Staff Report to the Zoning Administrator

Application Number: **211316**

Project Description: Proposal to construct an approximately 110 linear foot pin pier retaining wall, on-site with an existing single-family dwelling.

PIN PIER WALL & CONCRETE LAGGING
NTS

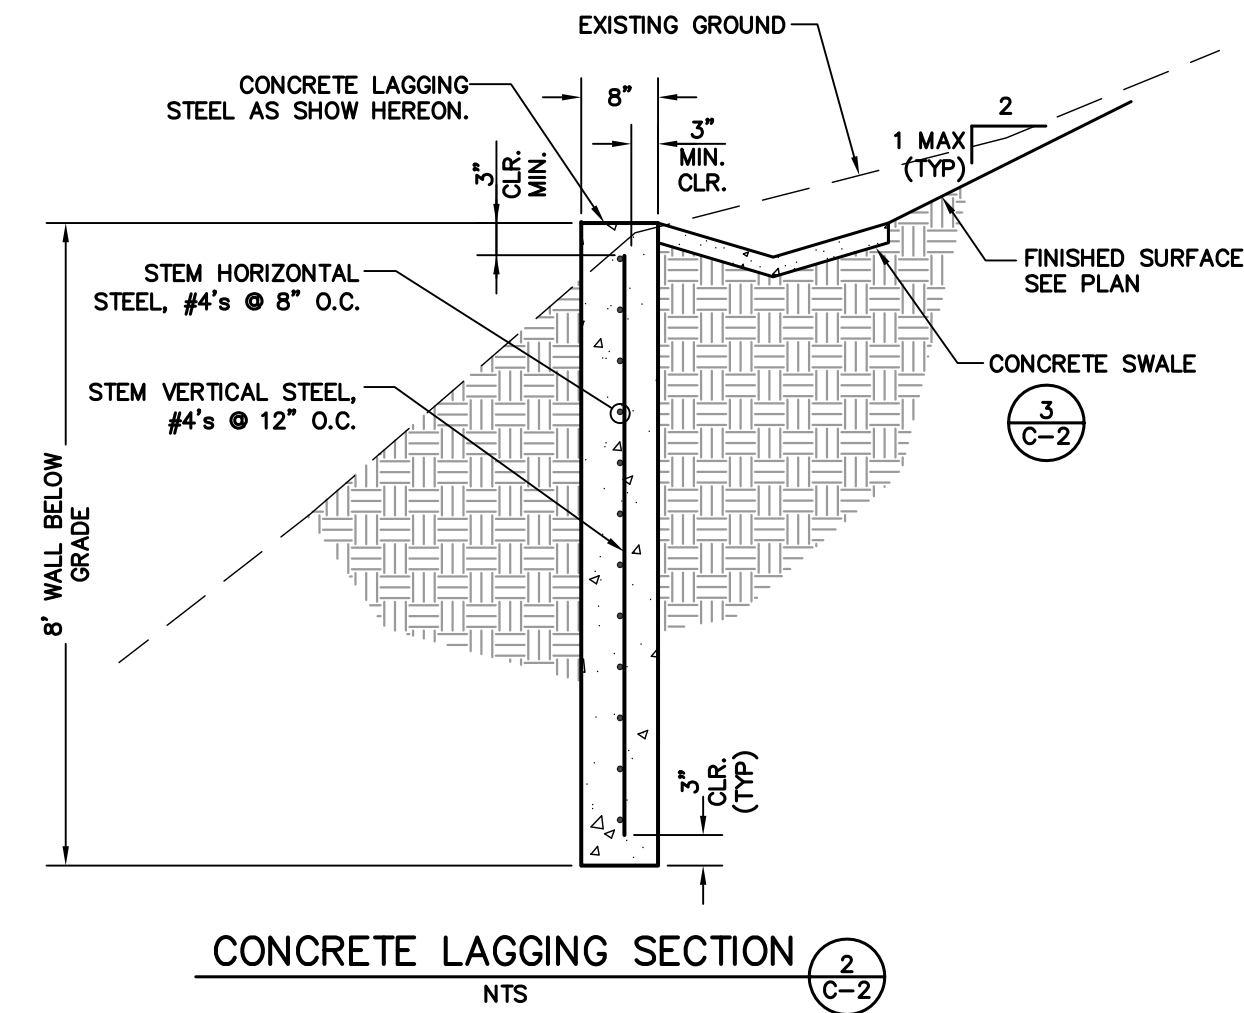
3. The current project civil engineering plans by R. I. Engineering, Inc. dated June 2021 show a soil pin retaining wall system with 30-inch diameter piers spaced at 2.5 diameters on center and an 8 feet deep grade beam/buried retaining wall between the piers immediately adjacent the 266 Cliff Drive seaward parcel line. The accepted project site geotechnical report recommends a 4 feet deep grade beam between the piers. Construction of the proposed 8 feet deep buried retaining wall system immediately inboard of the parcel line has the potential to destabilize the adjacent seaward parcel soils.

Exhibit H
Attachment 2

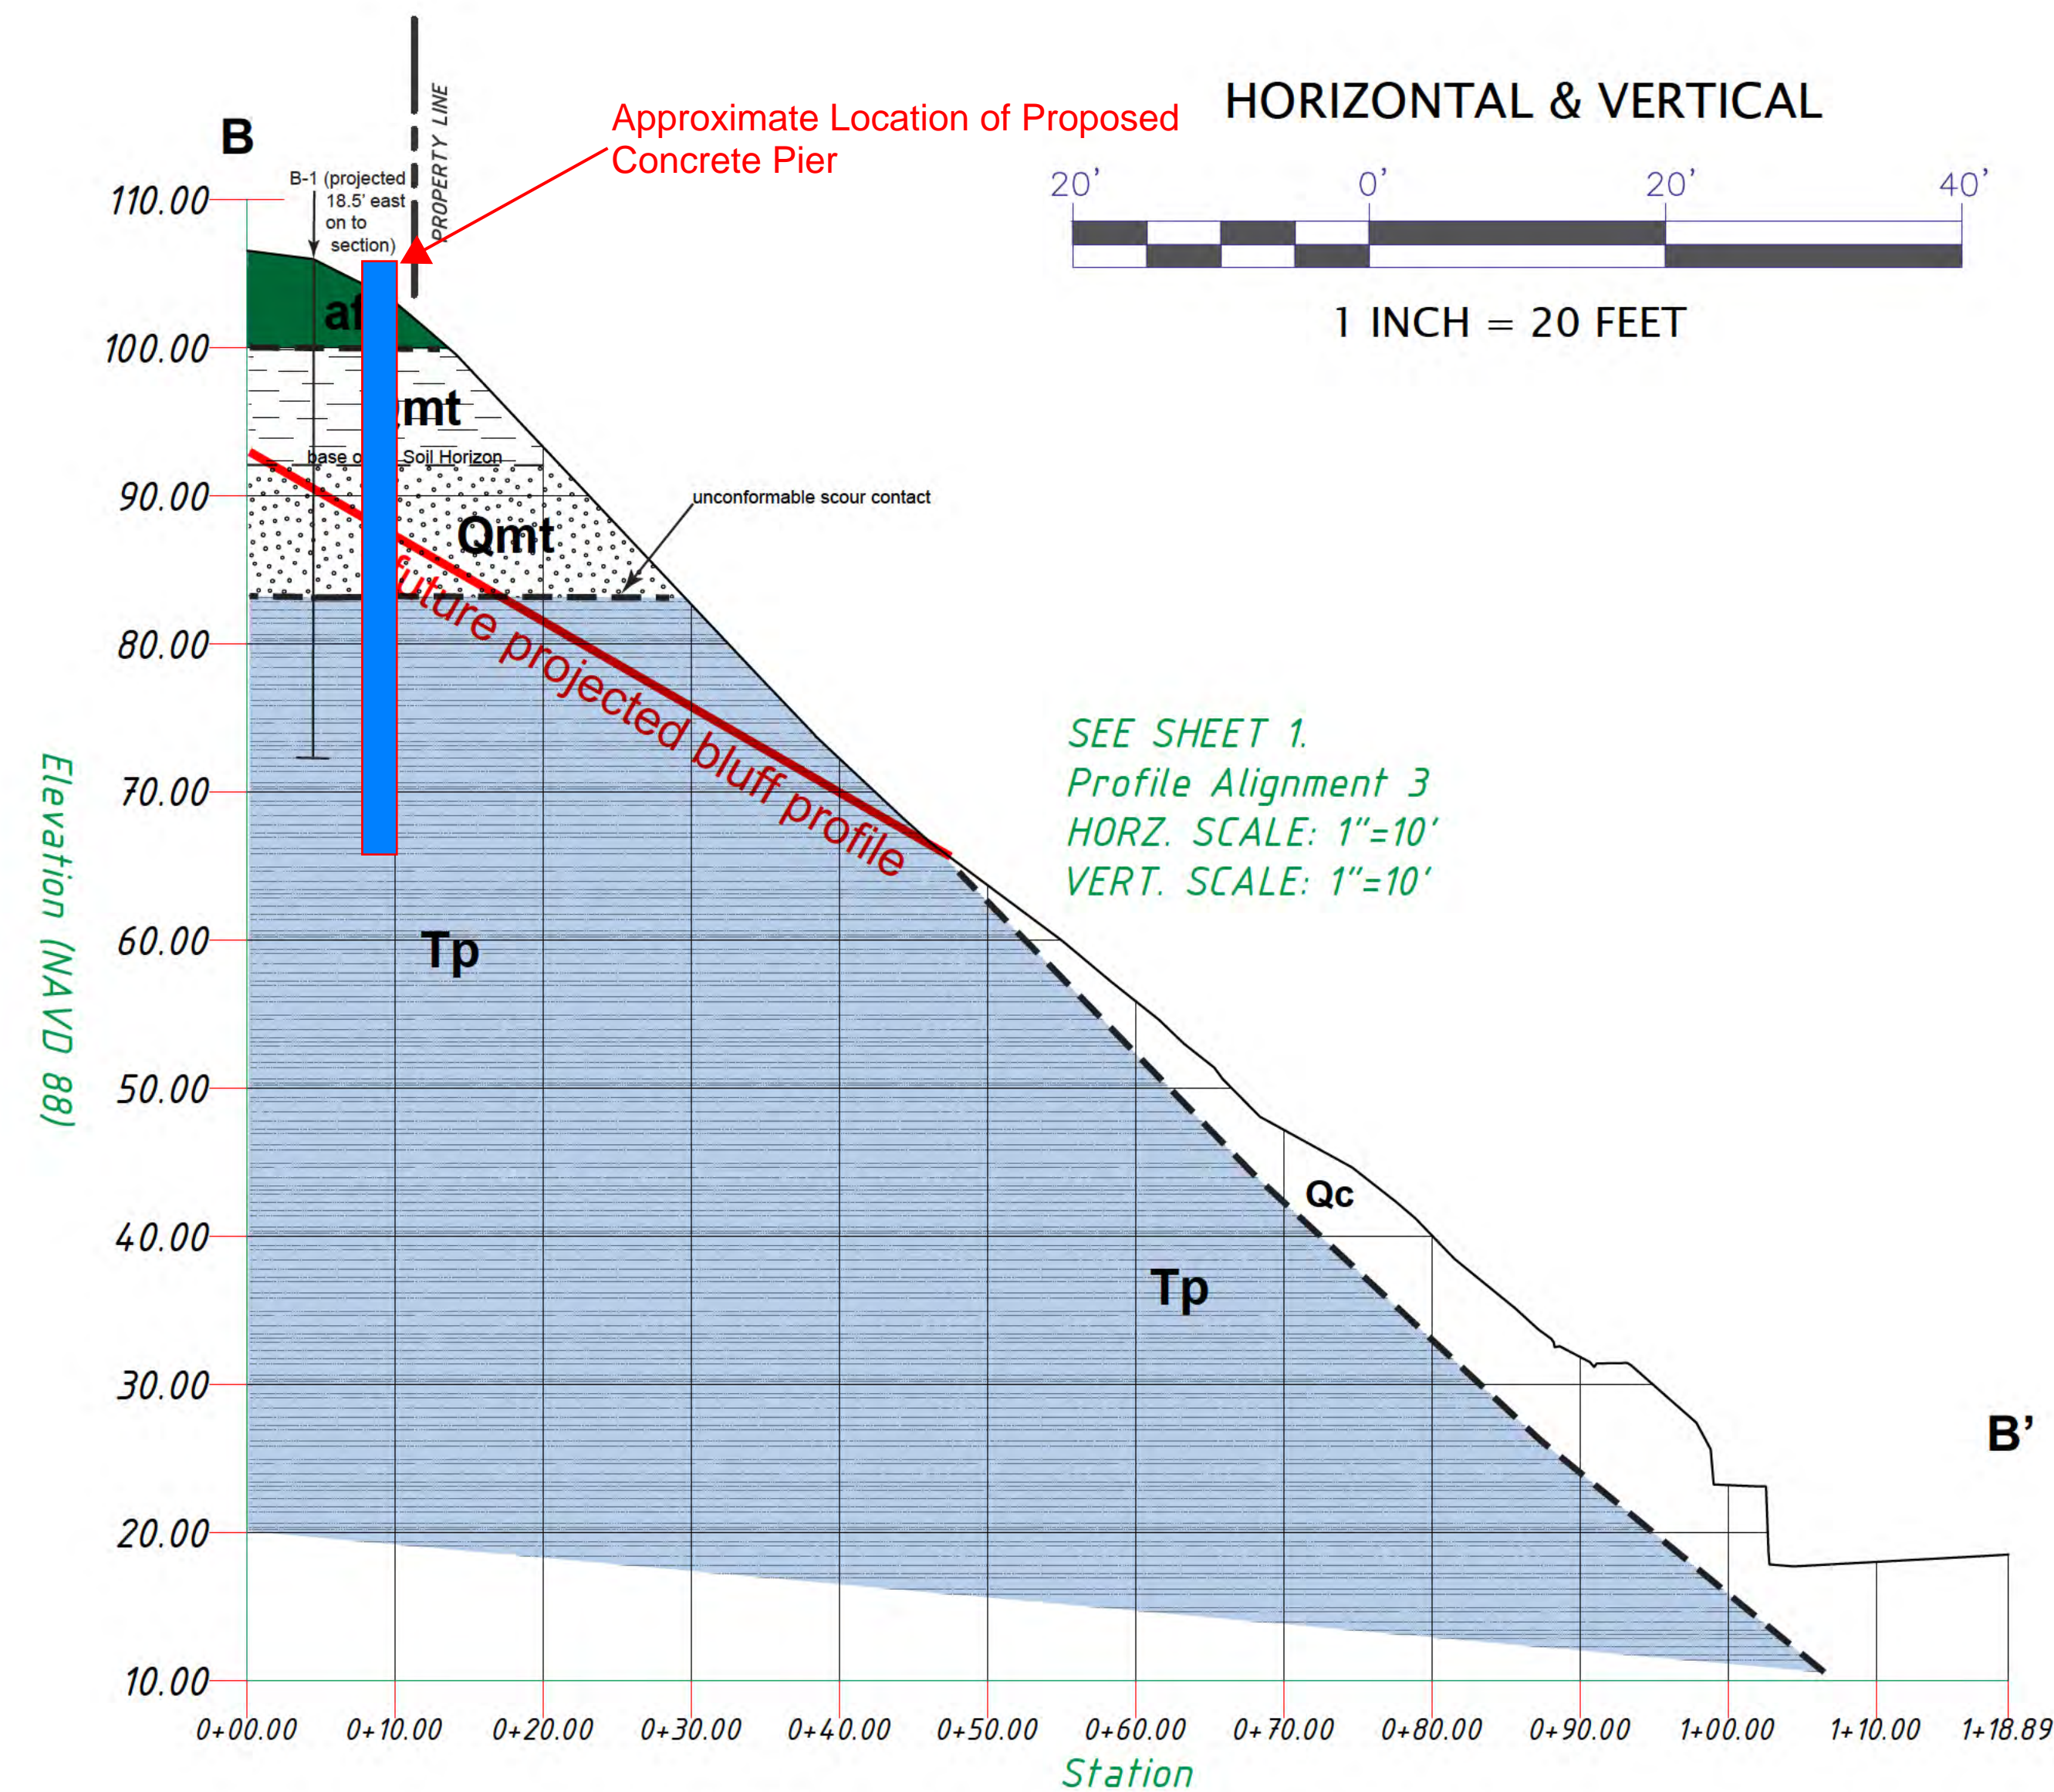
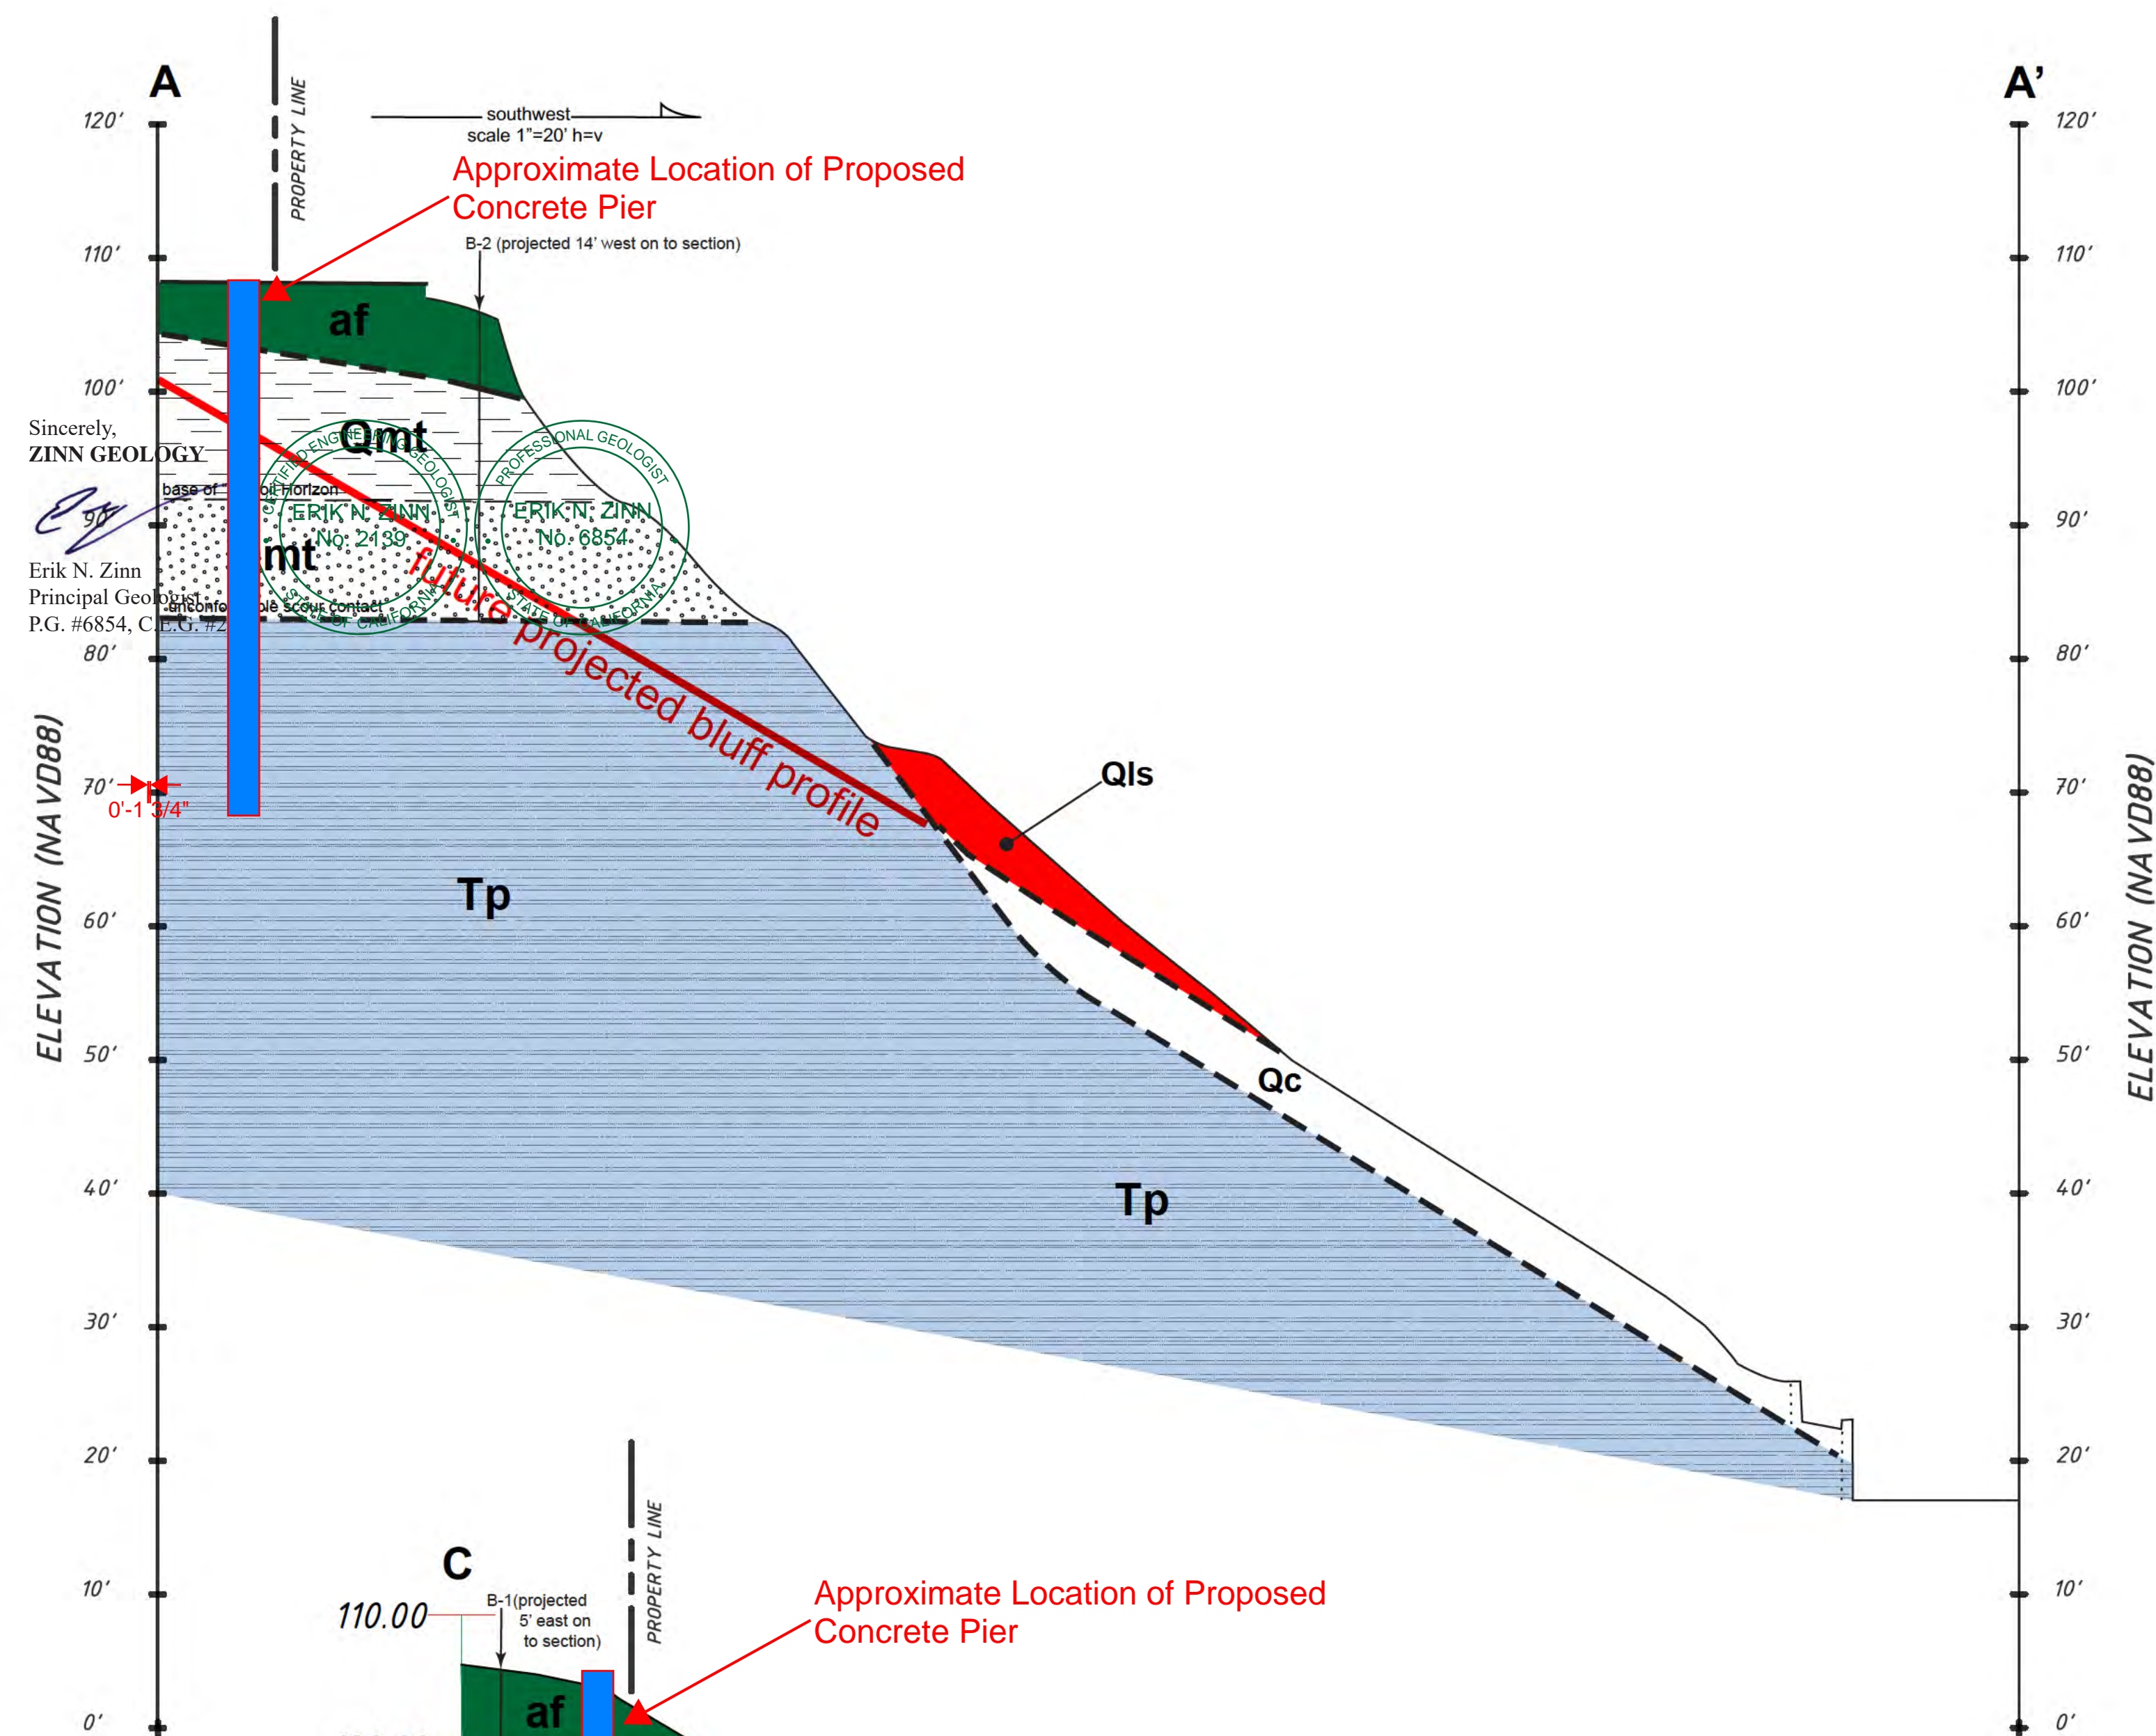
Attachment 3 is a set of geologic cross sections prepared for the project by the applicant’s geologist, Zinn Geology. The geologic cross sections are depictions of what would be seen on a vertical slice through the bluff oriented perpendicular to the bluff face. The approximate location of the proposed retaining structure has been added to the original illustrations. As can be seen from the cross sections, a large amount of soil exists in front of the wall, enough to generate several generations of landsliding of the type observed in 2019 and 2023.
